SICEEP, South West Plot (SSD6011) – Response to Transport for NSW

And Figure 3.9.1 of Appendix D_Supplementary Public Domain Design Report for SSDA5

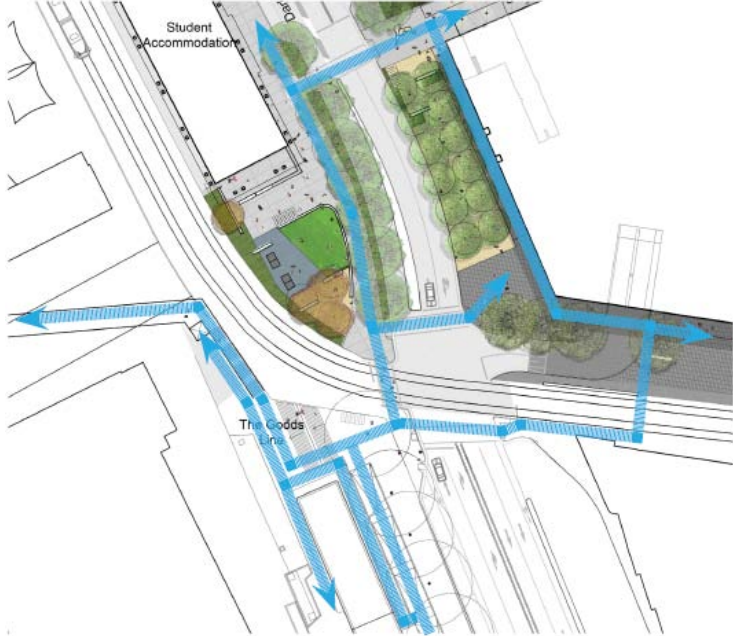
Condition C4	Amend to reference the Australian Standard not specifically Appendix D which isn't applicable to queuing. .
Condition C5	Condition acceptable.
Car Parking	
Condition C6	Condition acceptable.
Condition C7	Condition acceptable.
Traffic Signal Works	
Condition C8	Disagree, this is within SSDA3.
Condition C9	<p>Disagree</p> <p>There is provision under the RMS Traffic Signal Design (Section 2) which provides exceptions to the need for marked foot crossings if there is a parallel grade separated pedestrian facility provided, such as what is provided by the shared zone throughout Hay Street.</p> <p>Hay street is a shared zone throughout with the exception being the set down zone at the traffic signals at the intersection of Darling Drive and Hay. Desire lines for pedestrians moving north from the southern side of Hay will do not require the proposed traffic signals as demonstrated by the below diagrams/studies from the response to submission.</p> <p>Refer Drawing SKCPD095 from Hyder's Response to submission</p>
